LURLEY 24 CLASS.

DRG. NO H.24/5

MODIFICATION TO RUDDER
STOCK POSITION.

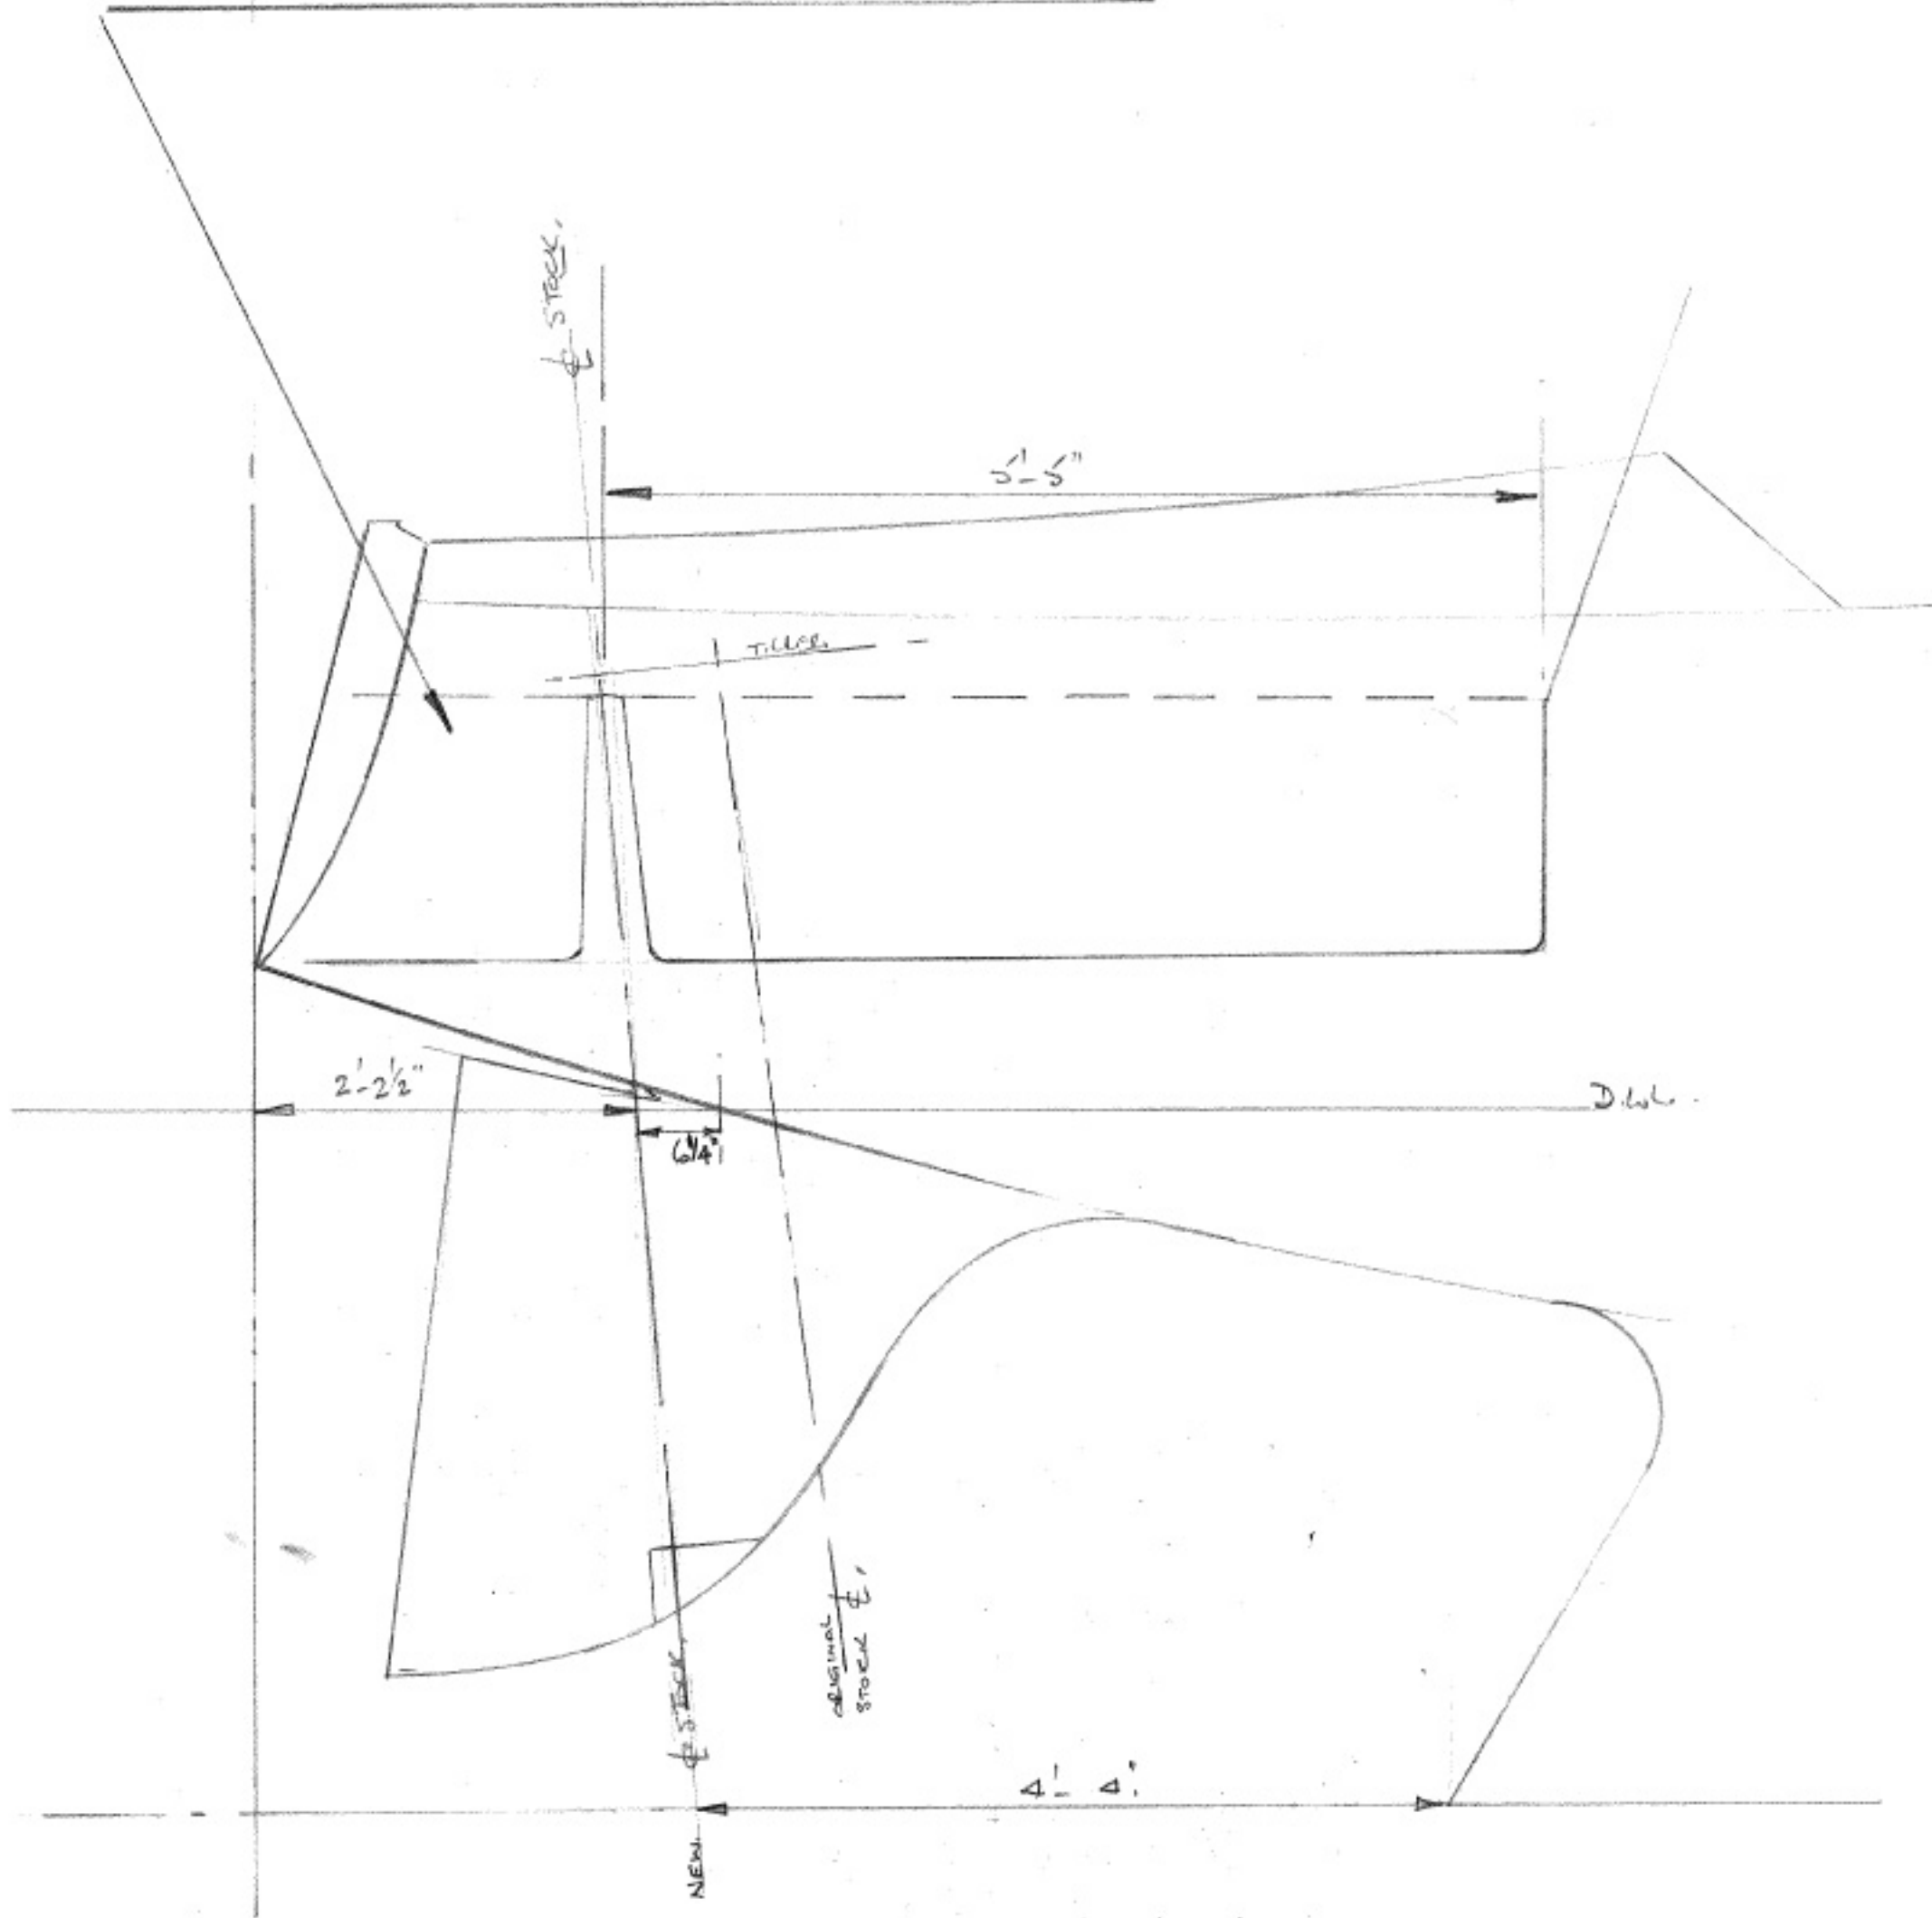
CHECK AT PLUG THAT A MOUNTED
3.9 CHRYSLER O/B MOTOR WHEN FULLY
TILTED WILL CLEAR STOCK BULKHEAD.
